US NRC

SUBJECT: RESPONSE TO REQUEST FOR ADDITIONAL INFORMATION REGARDING REACTOR BAY VENTILATION SYSTEM UPGRADE AT THE PENN STATE BREAZEAL REACTOR (EPID L-2019-LLA-0089)

## RESPONSE TO REQUEST FOR ADDITIONAL INFORMATION

**ORGANIZATION CHART**

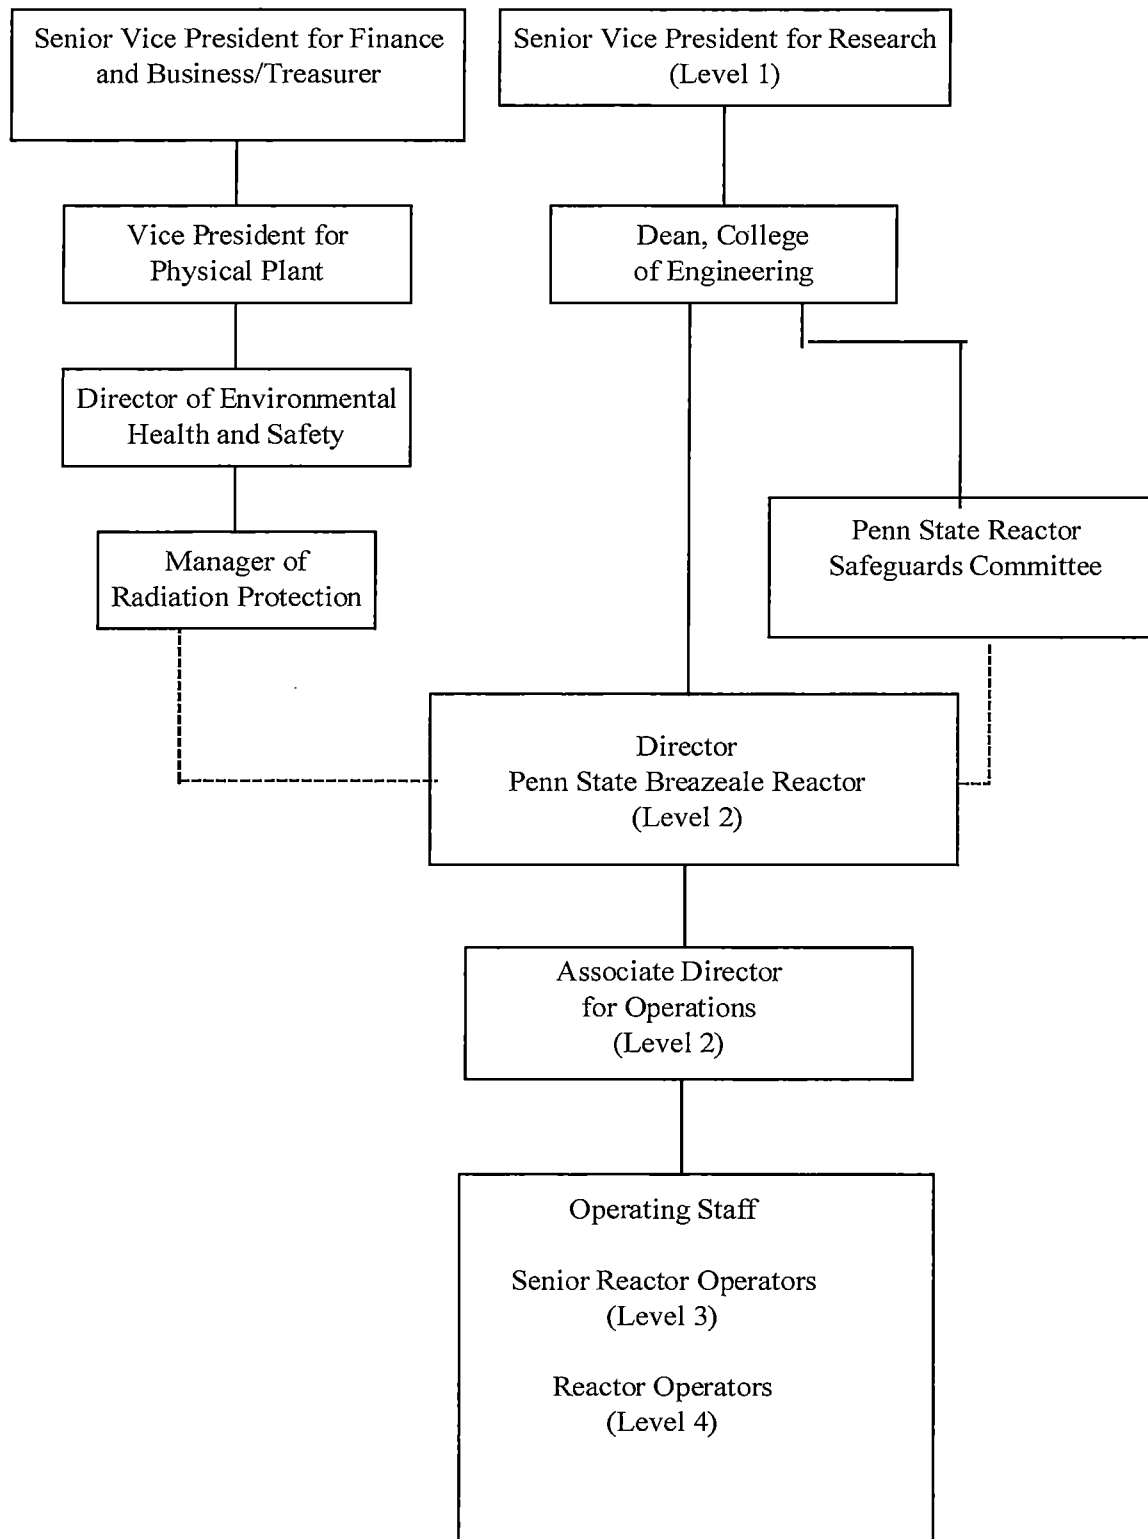
Note that in addition to the response to the questions in the RAI, the facility also requests an additional editorial change to the Technical Specifications Section 6.1 in order to update the title of the Level 1 administrator.

| 14 | 6.1.1<br>6.1<br>Organizational Chart | The title of the Level 1 administrator has been updated from "Vice President for Research / Dean of the Graduate School" to "Senior Vice President for Research" to reflect title changes at PSU. | The actual position referred to in TS is not changed.   |

The University Senior Vice President for Research (level 1) has the responsibility for the reactor facility license. The management of the facility is the responsibility of the Director (level 2), who reports to the Senior Vice President for Research, Dean of the Graduate School through the office of the Dean of the College of Engineering. Administrative and fiscal responsibility is within the office of the Dean.
